**TOWN OF WINTER PARK
PLANNING COMMISSION
Tuesday, October 22, 2024 8:00 AM**

MEMO

TO Planning Commission
FROM James Shockey, Community Development Director
DATE October 22, 2024
RE Riverwalk at Winter Park, Lot 18 (PLN24-048)

2 LOT COVERAGE PLAN
1" = 30'-0"

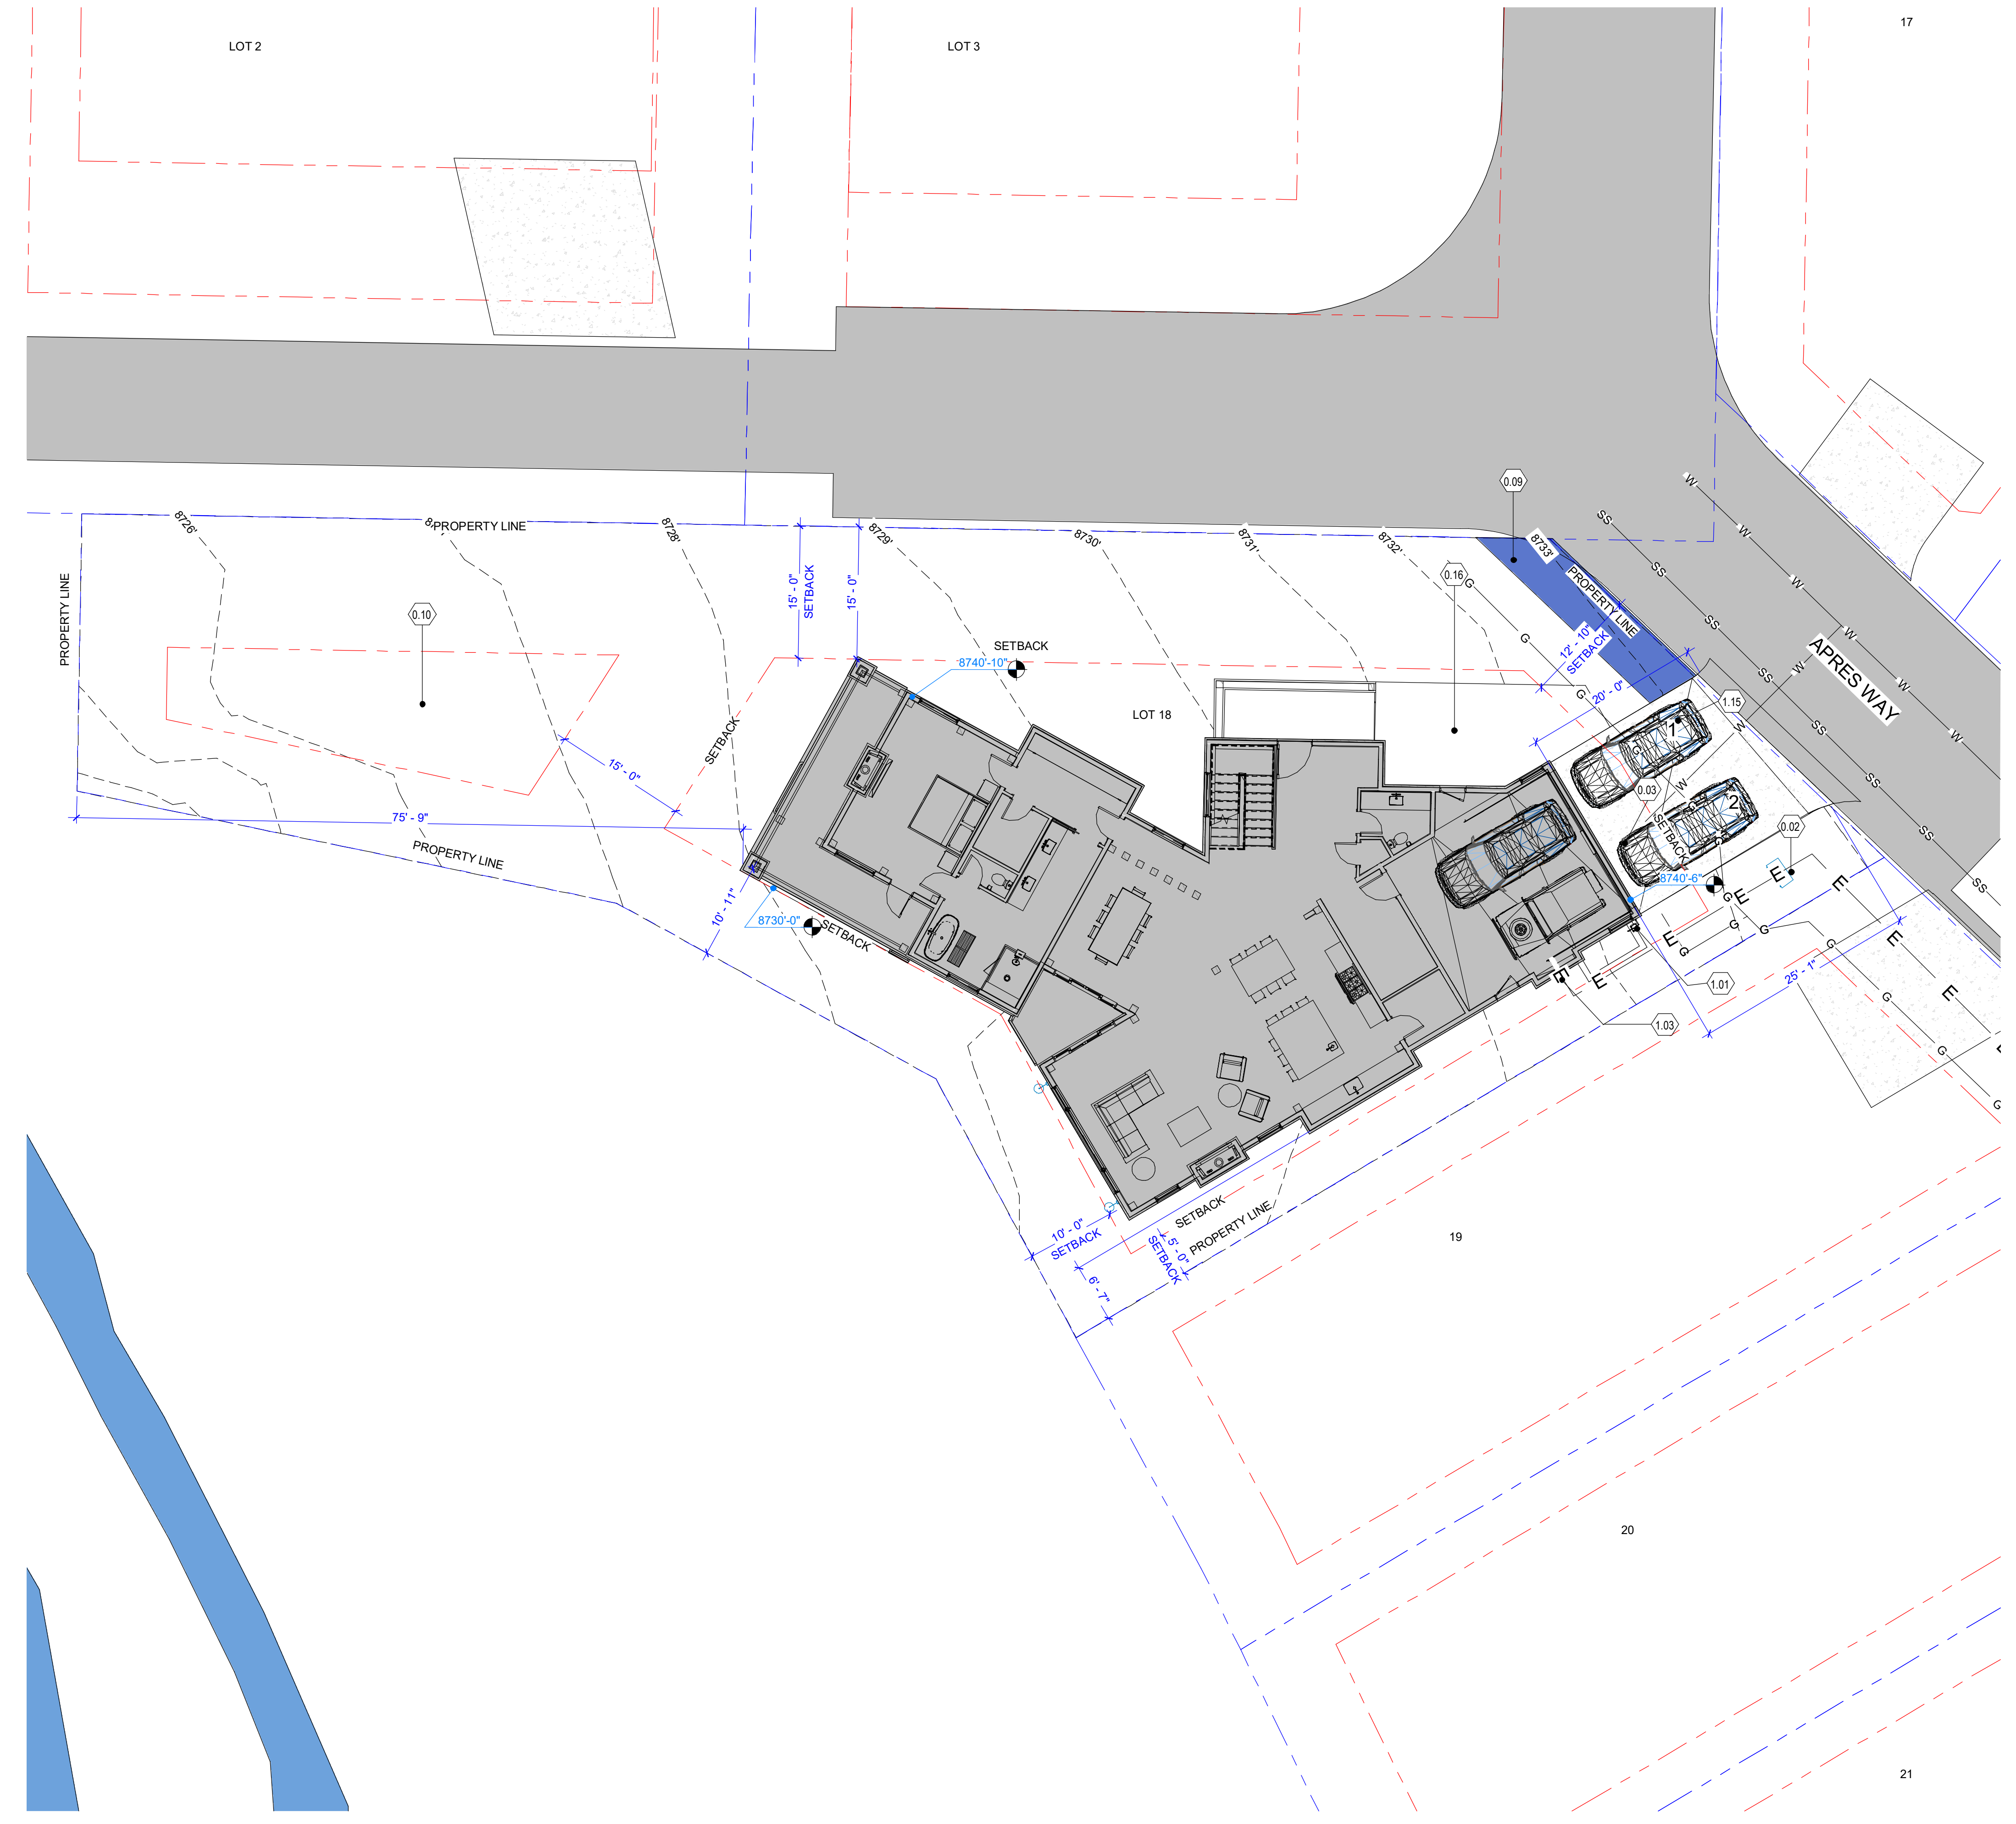
Satisfactory. The maximum building coverage is 40 percent (40%) as required by the R-2 zoning district and the approved FDP. The proposed dwelling has a building coverage of 39 percent (39%).

1 SITE PLAN
1" = 10'-0"

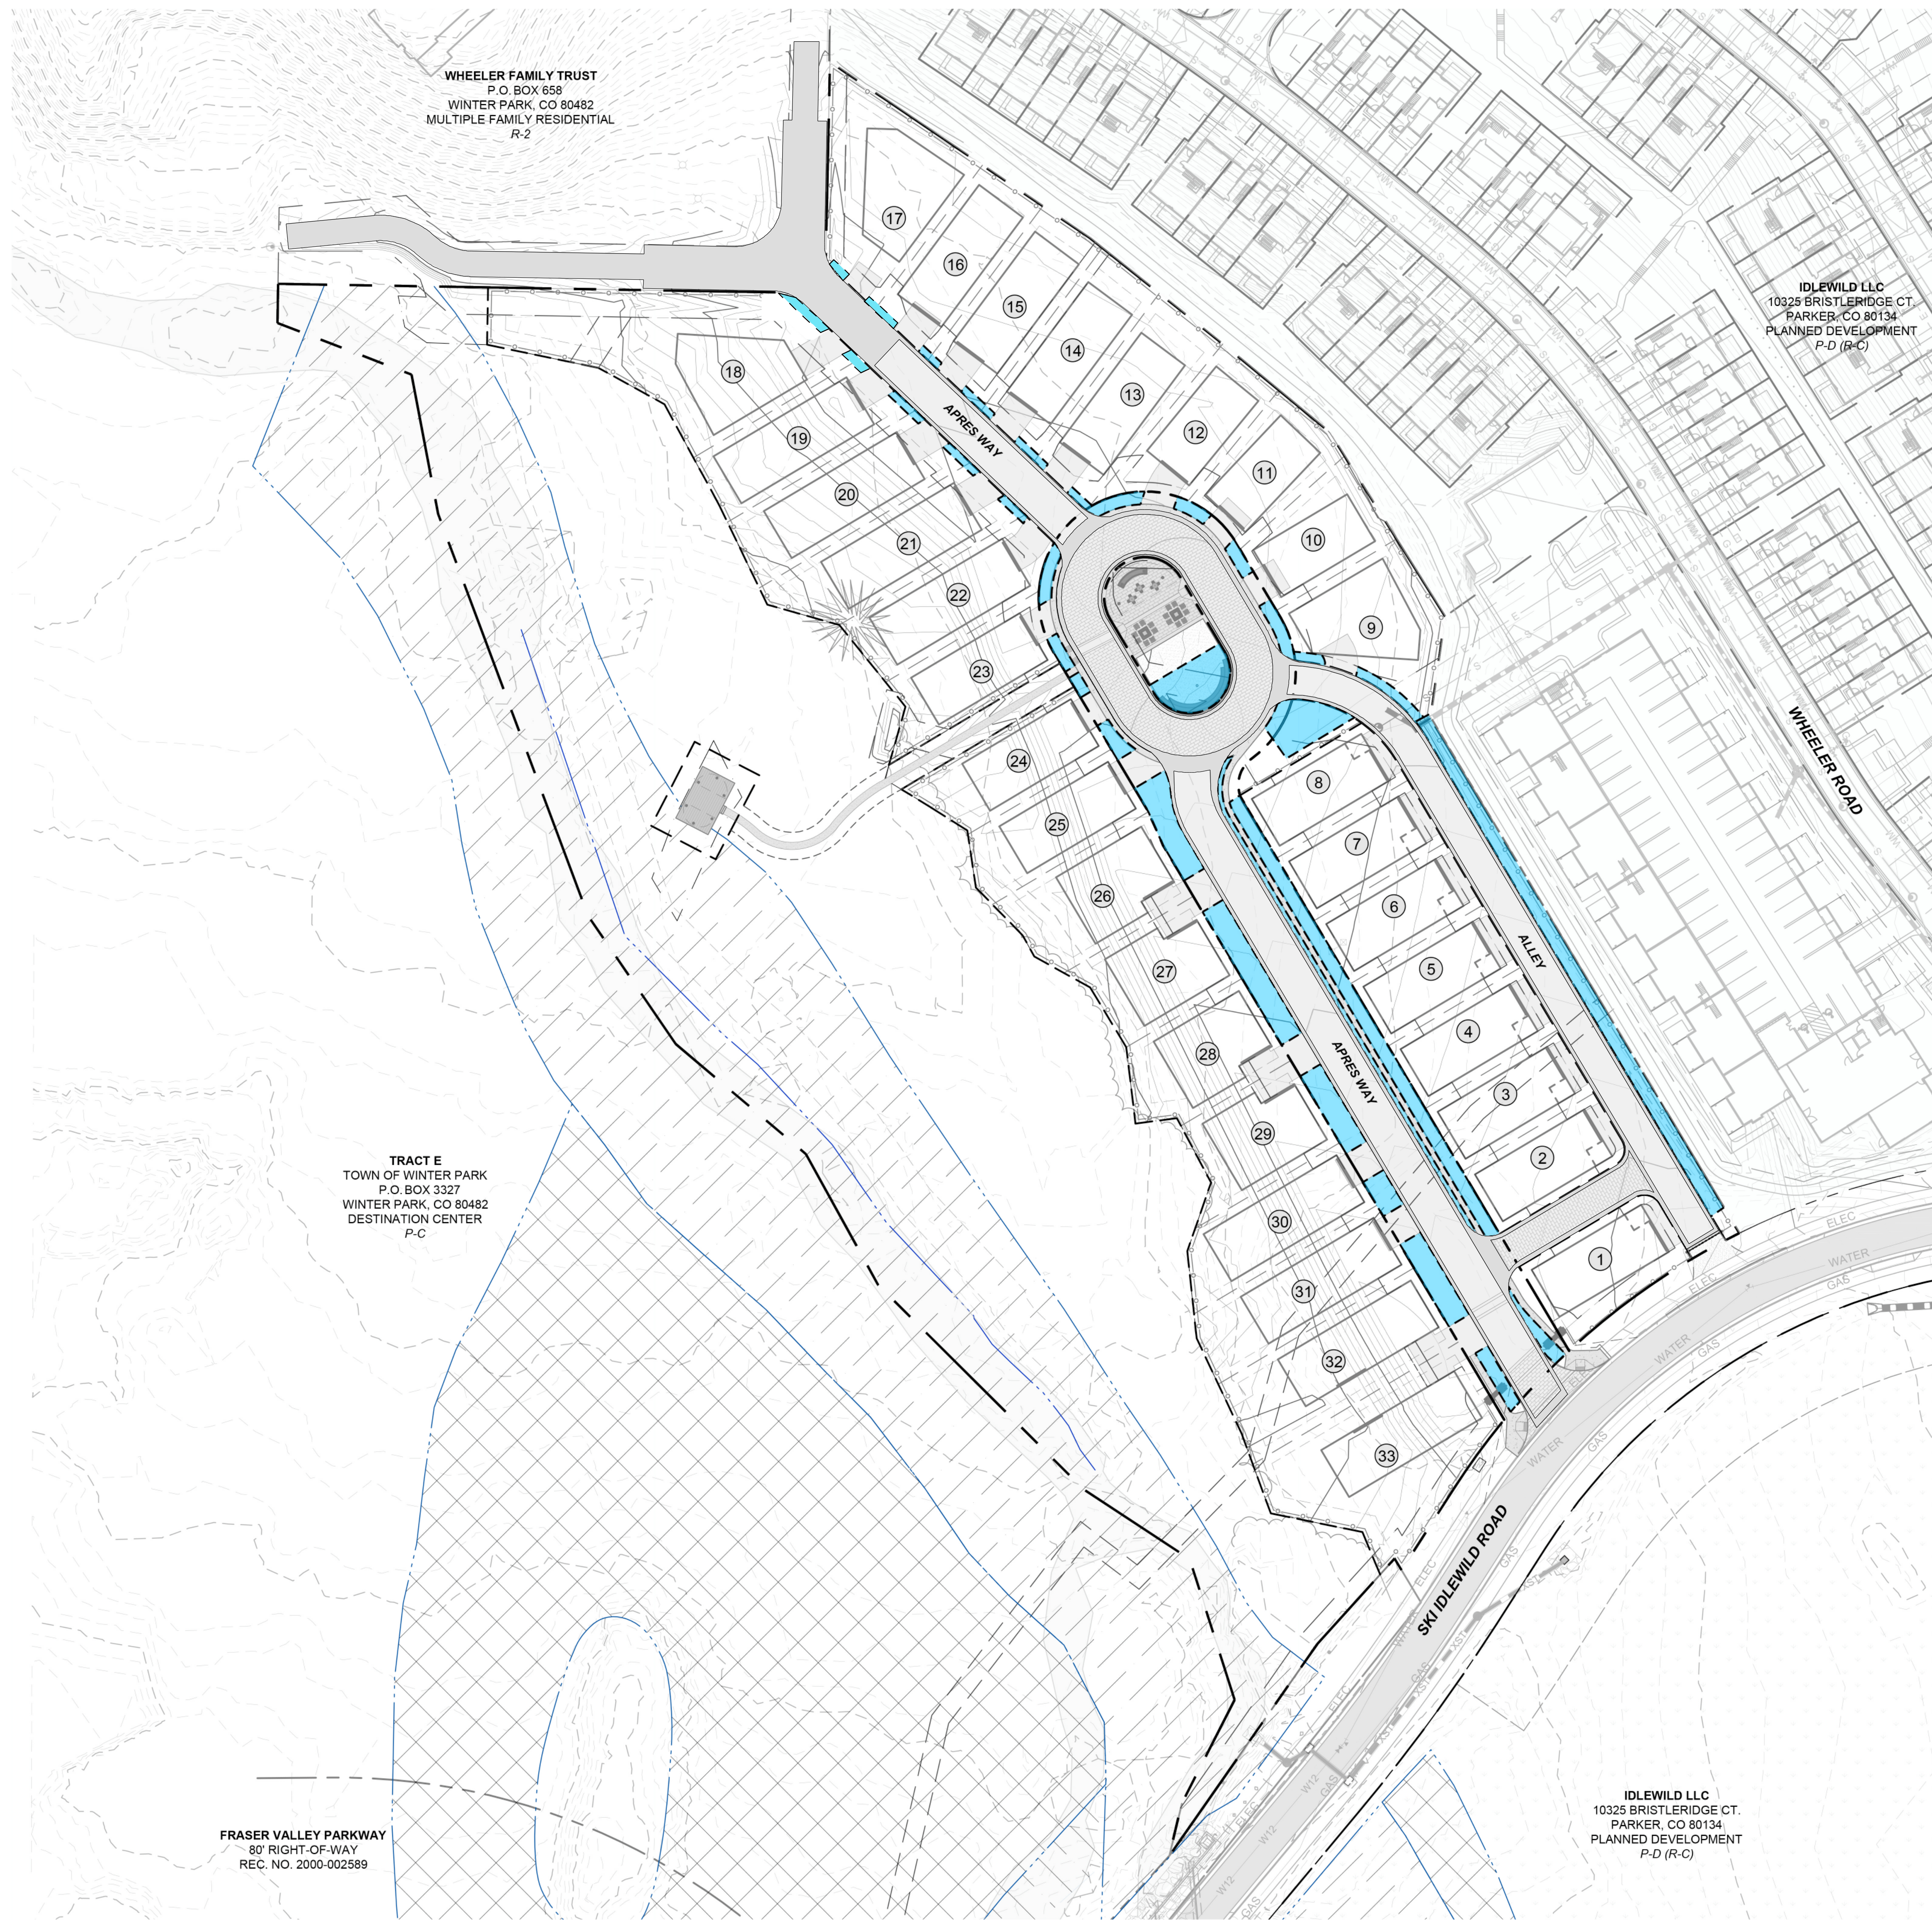
Partially Satisfactory. Overall, the Site Plan for Lot 18 provides all the information required for staff review. The building coverage does not exceed the maximum amount, 40% of the lot. The Limit of Construction does not extend into adjacent wetlands. A perimeter fence is required per the Riverwalk Final Development Plan. The applicant has proposed that the construction of the fence will begin within 3 years of the issuance of the first building permit. Staff is recommending the fence be tied to issuance of fifteen Certificates of Occupancy. S

- The Town shall not issue more than a maximum of 15 COs within the Riverwalk Filing 1 plat area until the perimeter fence required by the FDP is installed by the property owner and/or developer.

Satisfactory. The proposed driveway slope is 2.1 percent (2.1%) which is an acceptable slope. At midpoint the driveway is approximately 19.5 feet in length. The driveway at its shortest is 17.5-ft and at its longest

① GRADING AND DRAINAGE PLAN - SITE
1" = 10'-0"

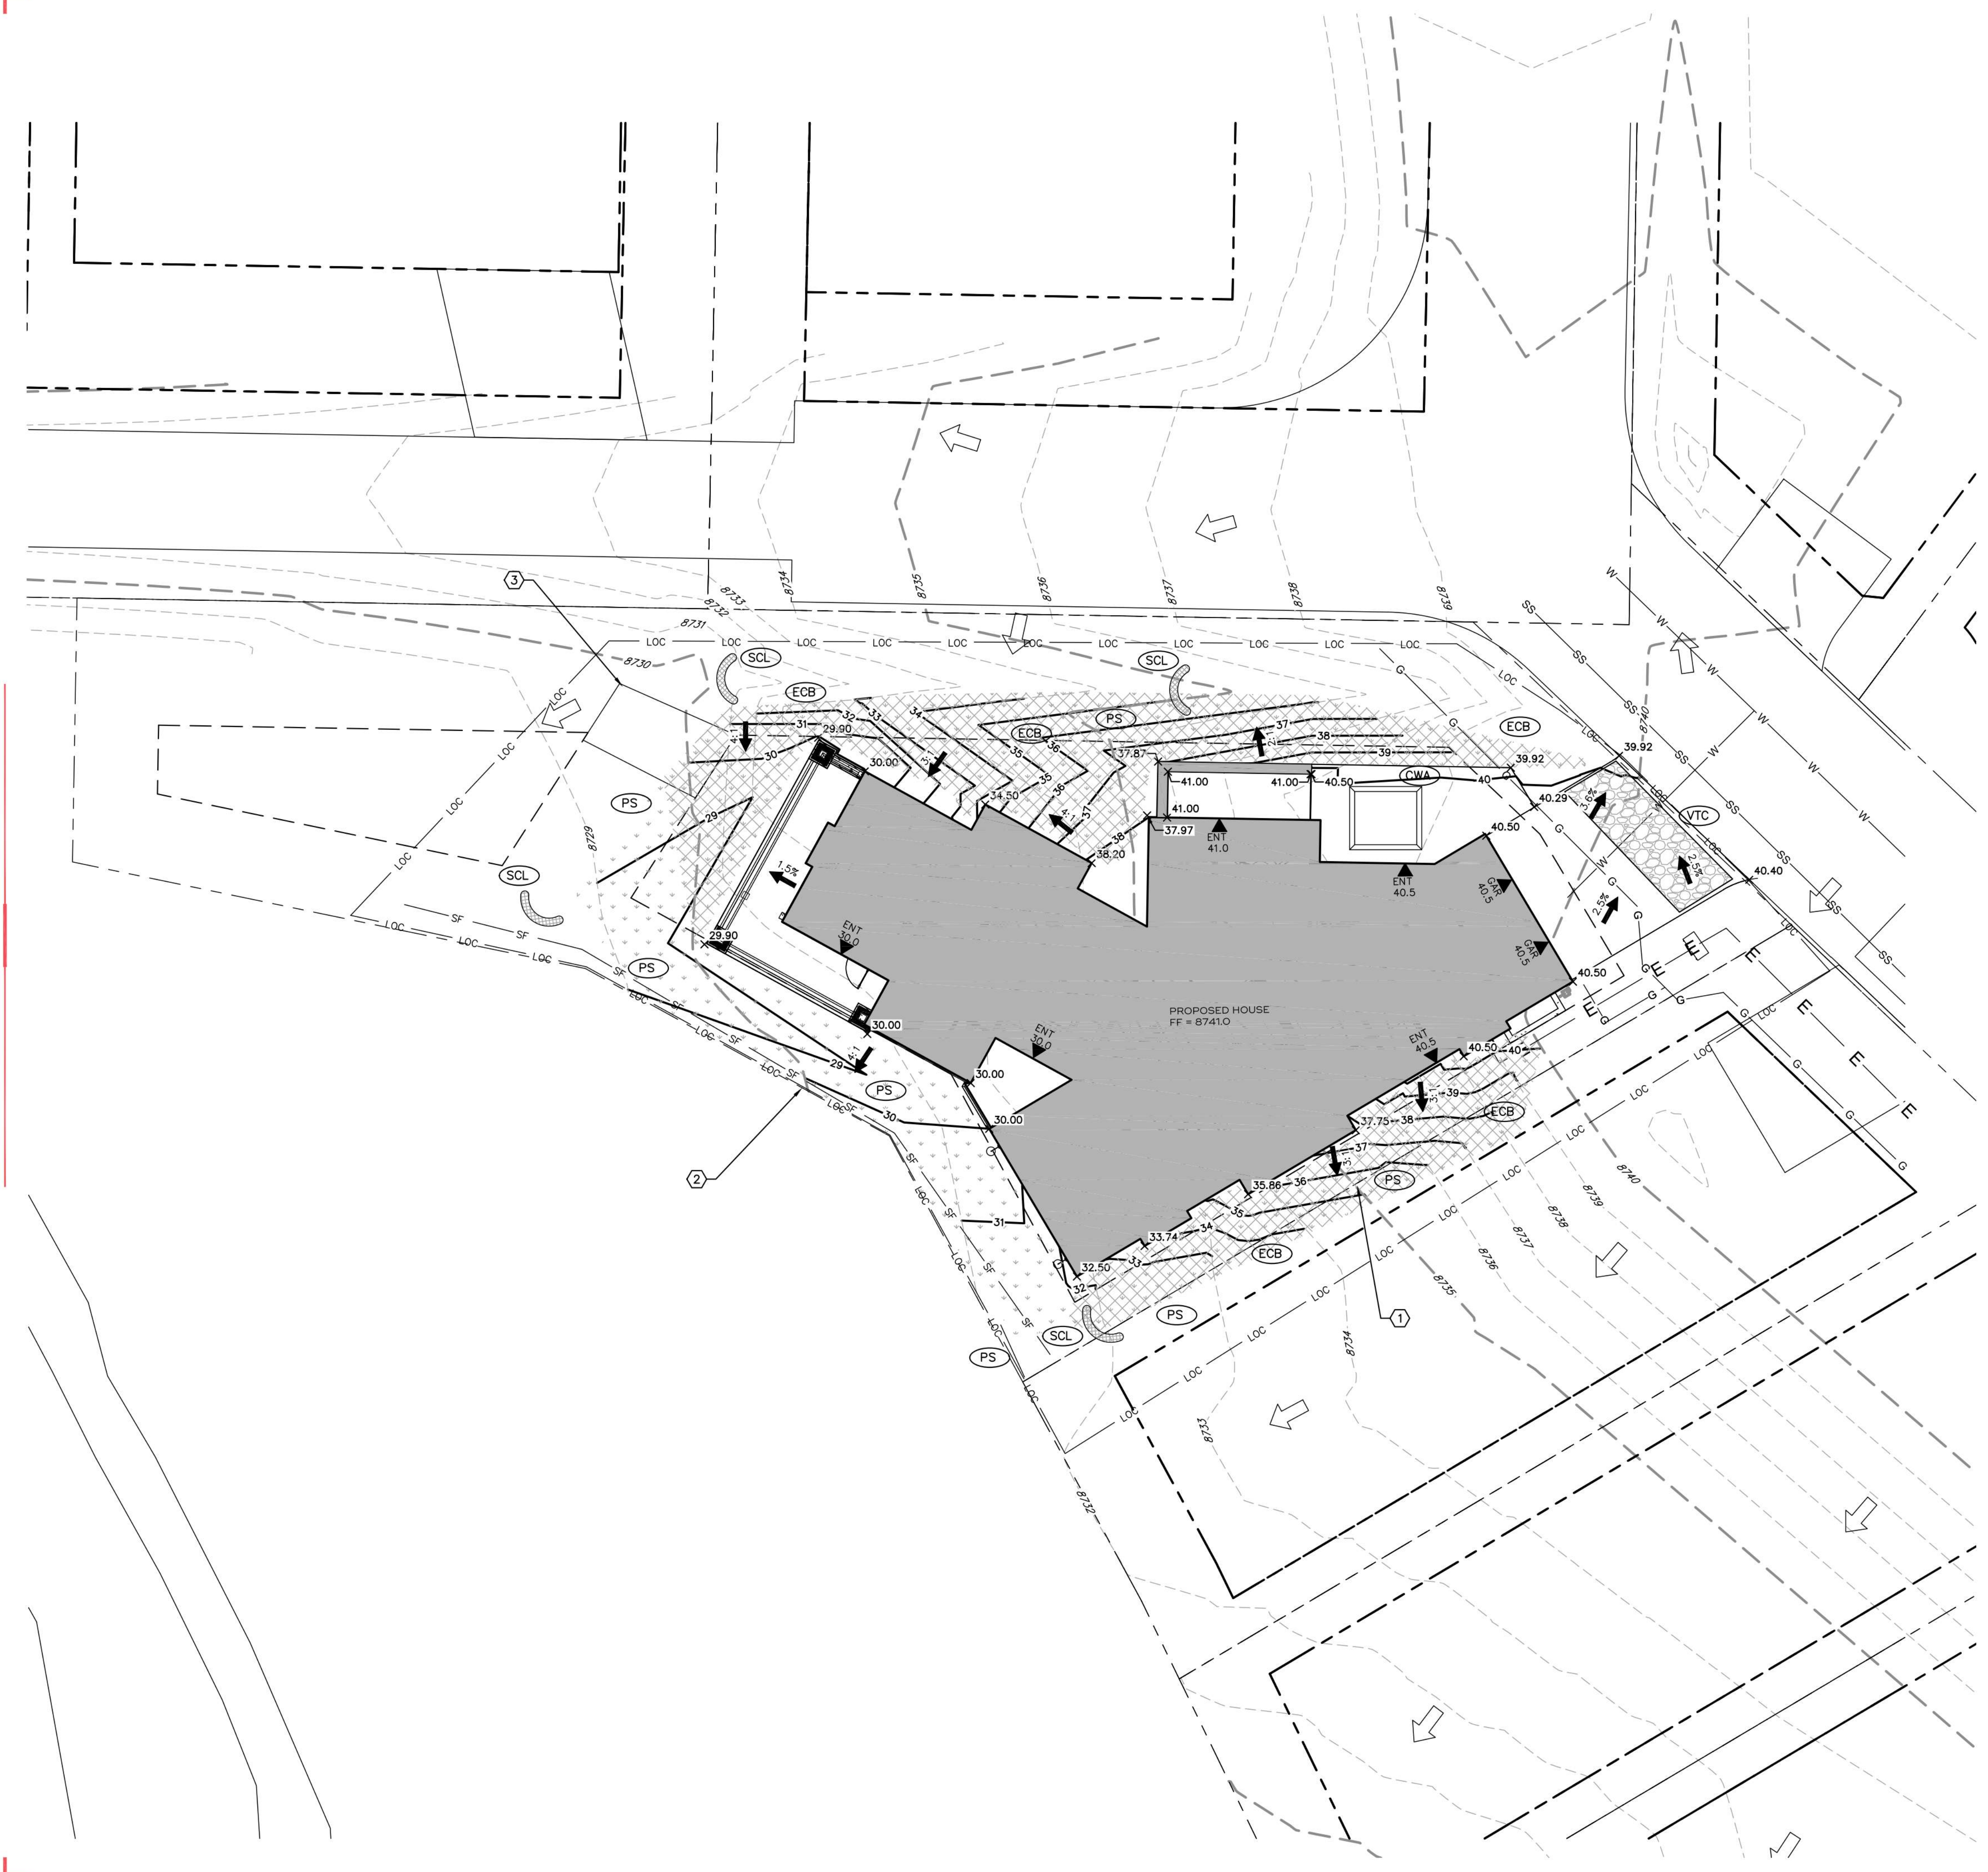
Satisfactory. The overall grading and drainage plan and drainage report were approved with the FDP and the submitted plan has been stamped by professional engineer.
